Friday, May 5, 2023

Lillian Kuri, Commission Chair

May 5, 2023

FW 2023-04 & 05

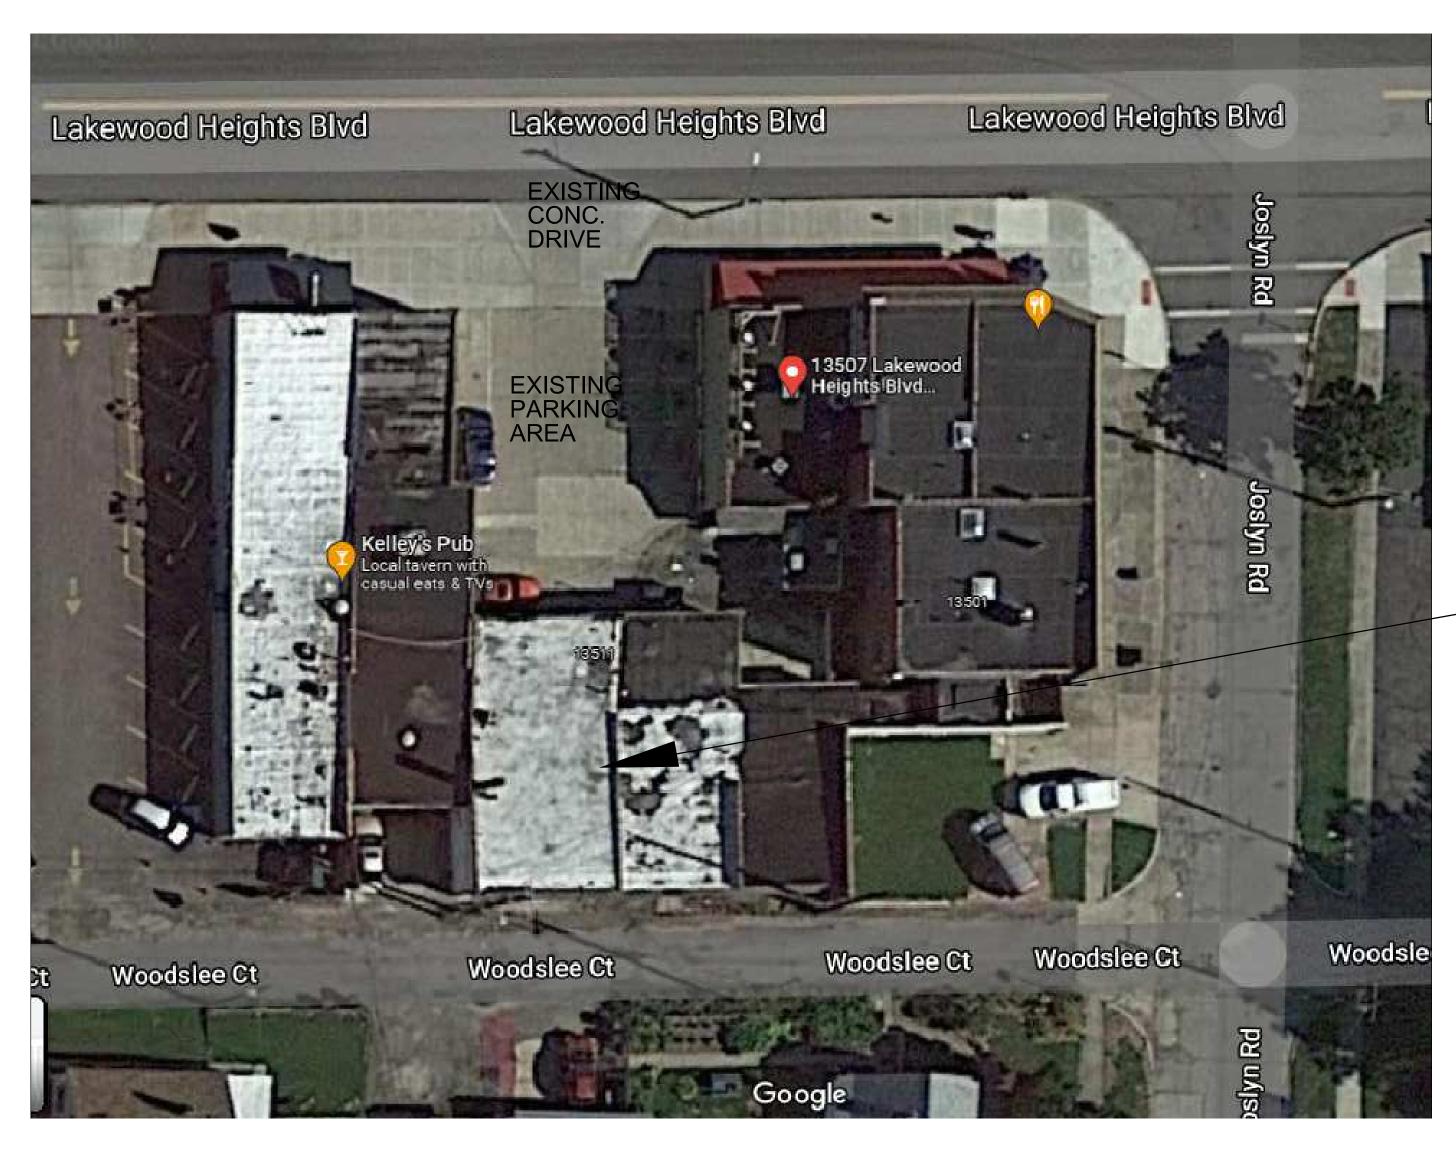
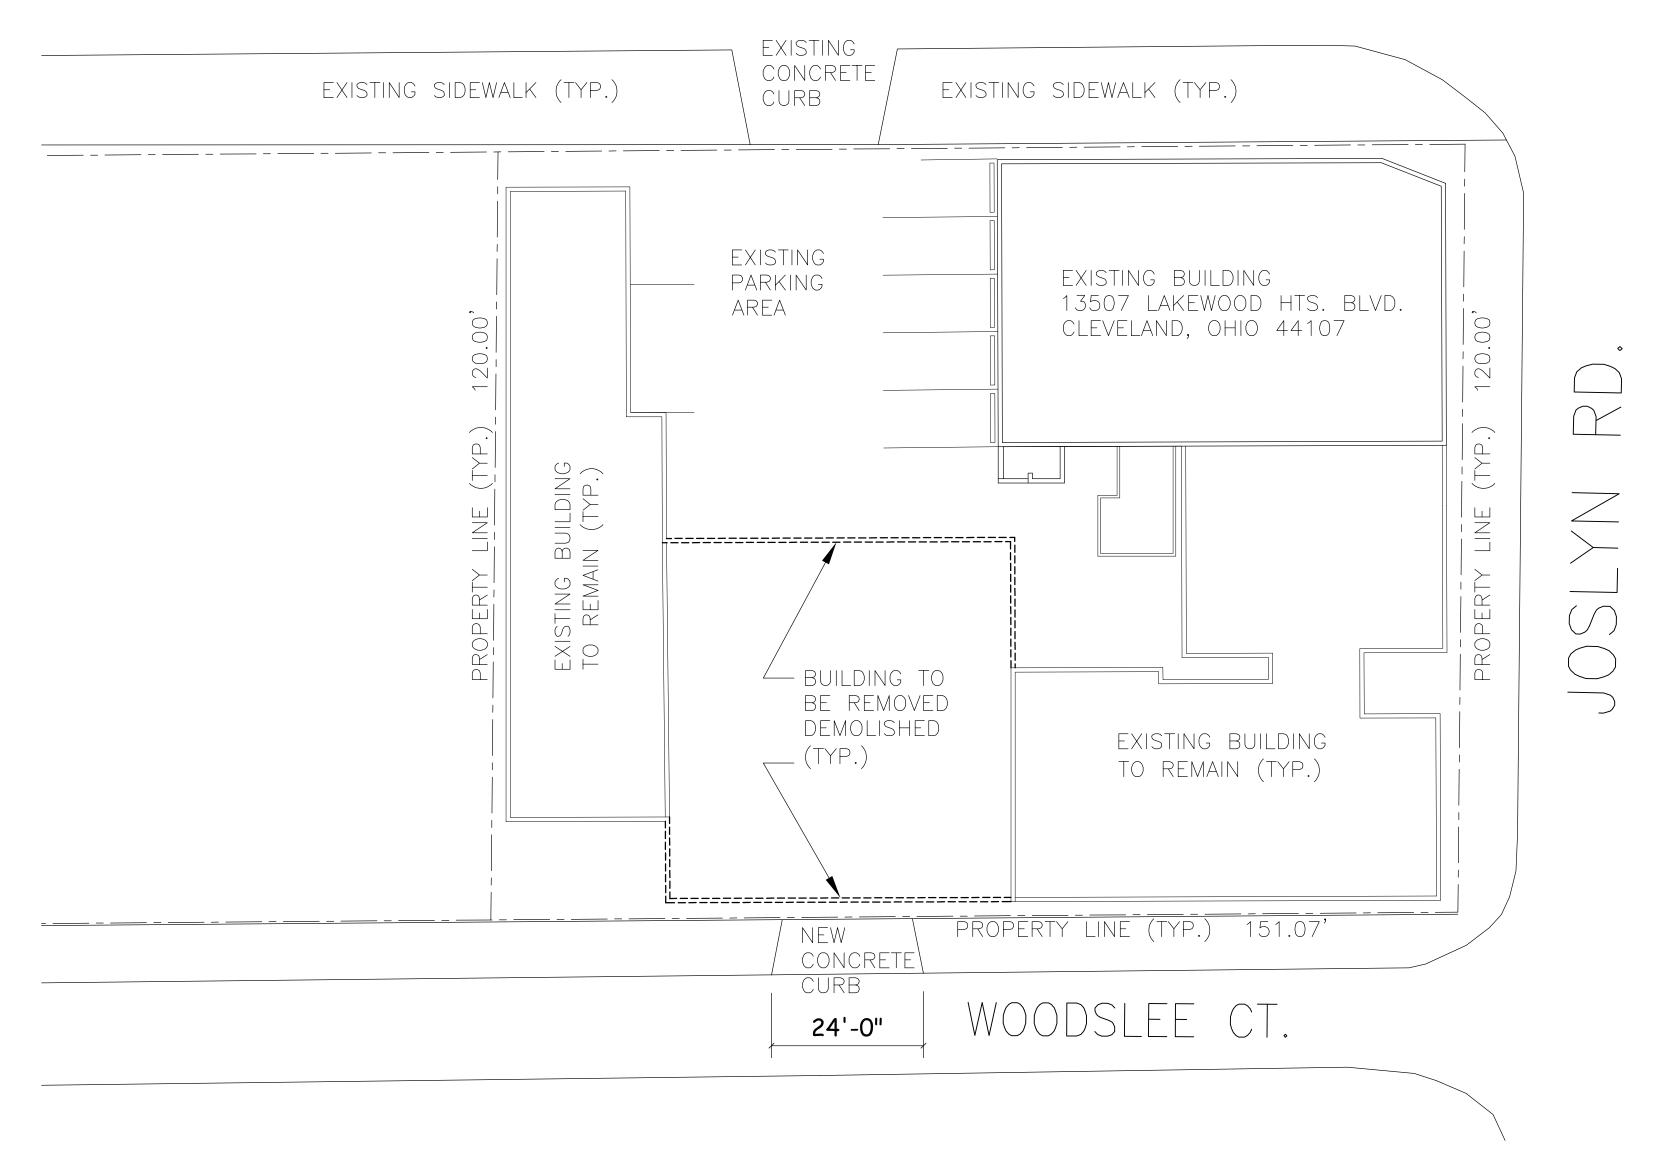
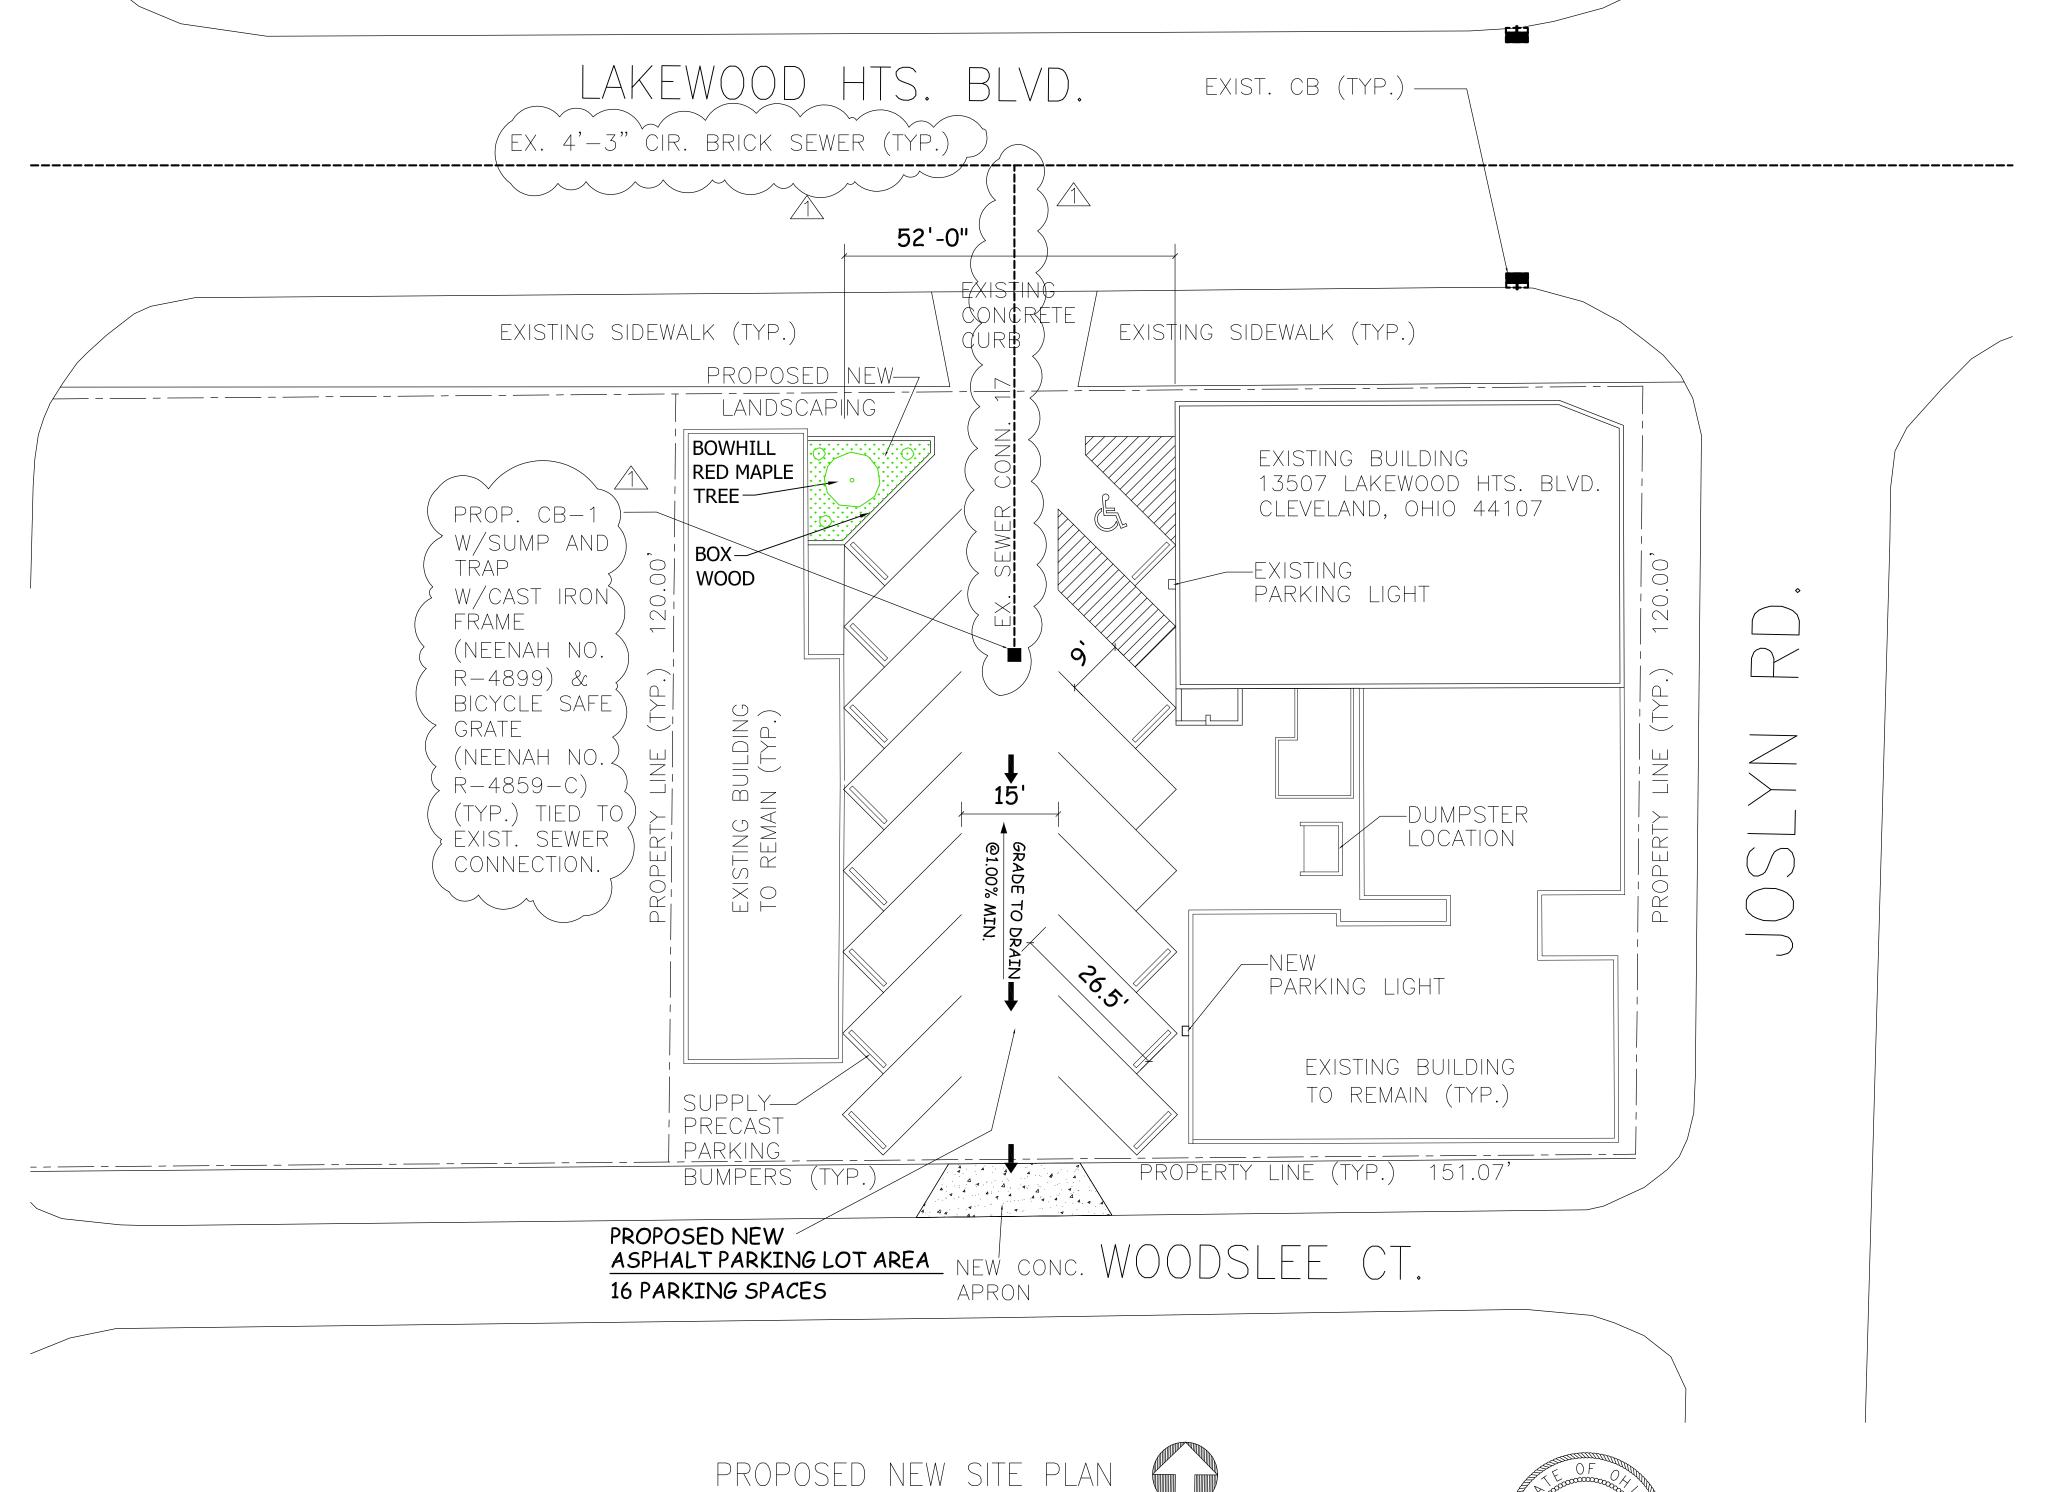
Revise eastern ADA parking lot to show cross-hatching, the loss of one parking space, and planter area; add information to site plan to show tree placement in planter; omit wheel stops at dumpster access.

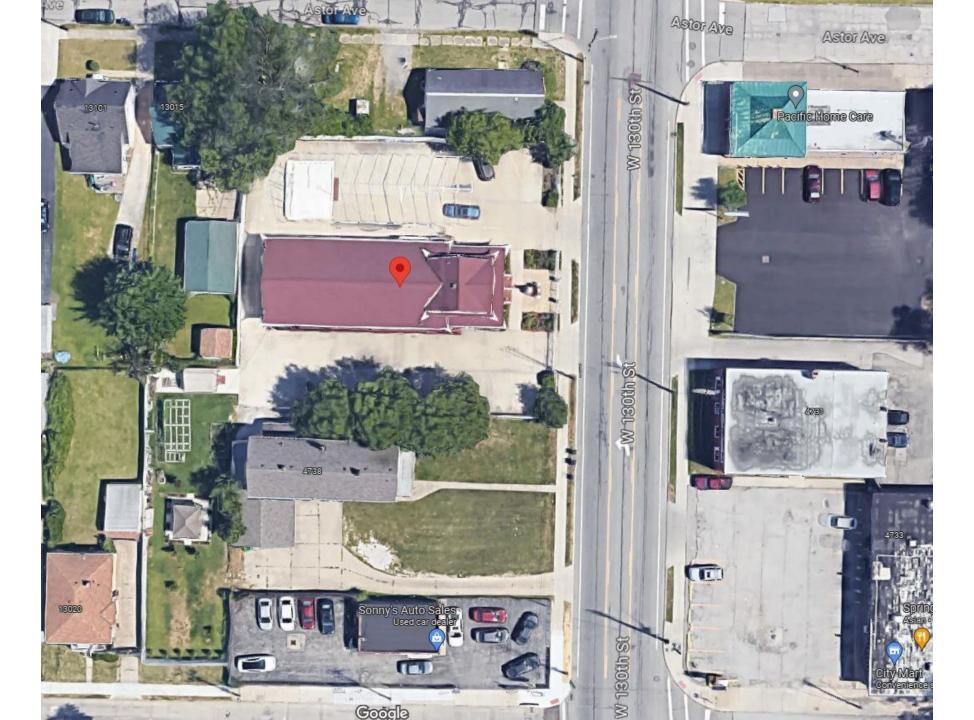
Need clarity on fence condition; eliminate center curb cut; refine site plan, adding greenspace wherever possible; provide landscaping and lighting plan, also materials, for final approval.
